Interactive comment on **"Field-based groundwater recharge and leakage estimations in a semi-arid Eastern Mediterranean karst catchment, Wadi Natuf, West Bank"** *by* **Clemens Messerschmid et al.**

Anonymous Referee #1

Answers by: C. Messerschmid, J. Lange and M. Sauter (21 October 2018)

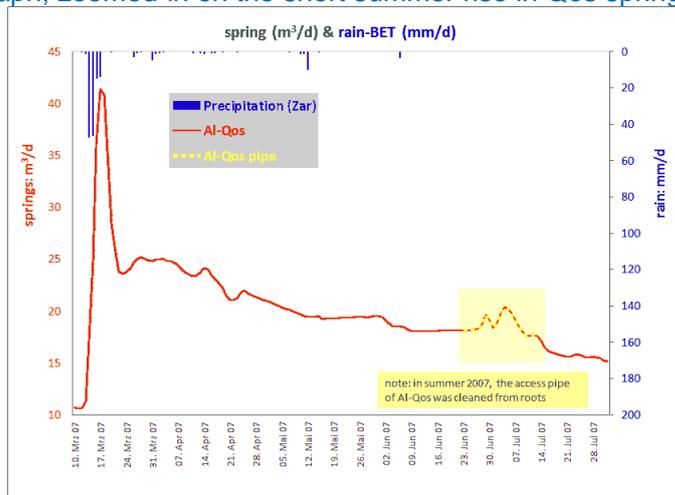
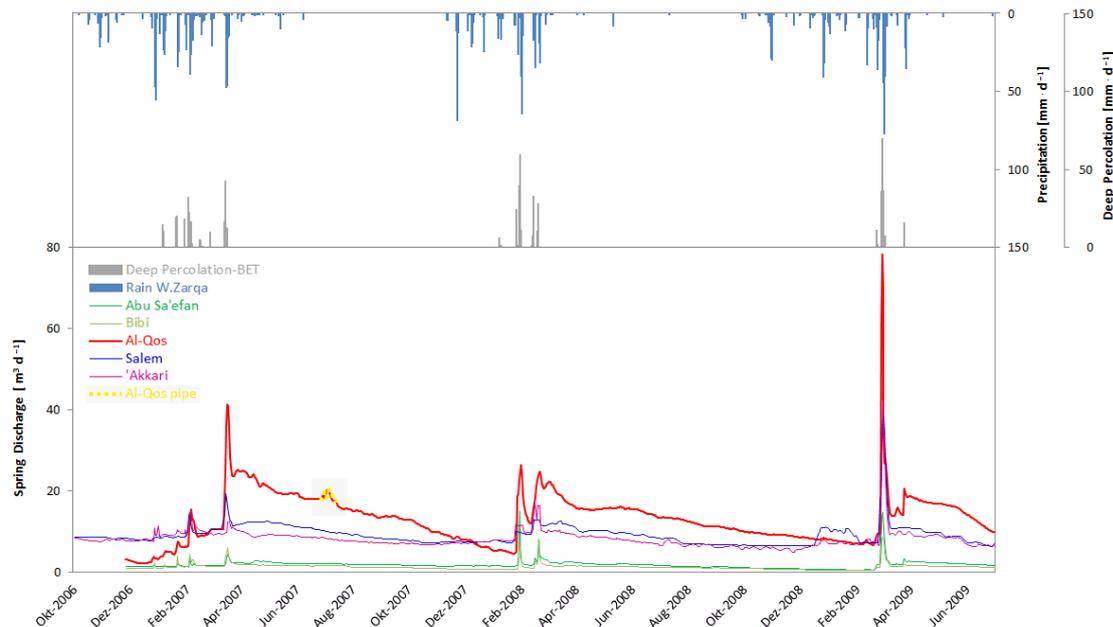
The caption of Figure 5 mentions the cleaning of one spring and the effect on its flow rate. The condition of the springs apparently affects their discharge. So, evidently this also affects groundwater recharge (see Eq. 5). Therefore, spring maintenance is an important factor for groundwater recharge, yet it is brought up only in a figure caption.

The caption calls the effect temporary but is appears to double the well production for at least two years and the effect was still very strong at the end of the observation period so there is no clear picture of the persistence of the effect. It seems obvious that the net recharge to the aquifer feeding that particular well changed in 2007 with effects that last well over three years. I have the impression that the authors did not consider any of this in their calculations, or carried out a scenario study to examine the effect of different well maintenance practices.

Thank you for this comment. You are correct. We created a misunderstanding, because we included a wrong formatting of Figure 5. This figure should only present the period from Oct-2006 until Aug-2009. (Before Dec-2006, we had large gaps in the reading of the 3 springs of Beitillu spring group. The formatting falsely indicated a continuous line

with a linear trend of decreasing discharge for Al-Qos spring during summer 2006. This impression is an artefact of erroneous formatting.)

In addition, the short period of raised spring flow in Al-Qos spring (from 23 June until 12 July 2007) was not clearly discernible in this graph. We here add for your information a graph, zoomed-in on the short summer rise in Qos spring flow (see figure below):

We shall therefore correct the formatting of Figure 5 for the new manuscript.

Thank you for this comment. As stated above, this is a misunderstanding. We are sorry to have caused this confusion. A preliminary corrected layout of the corrected Figure 5 is shown hereunder.

It is obvious that only a brief rise for several weeks was observed in Al-Qos spring. We believe that this makes an answer to your interpretation obsolete.
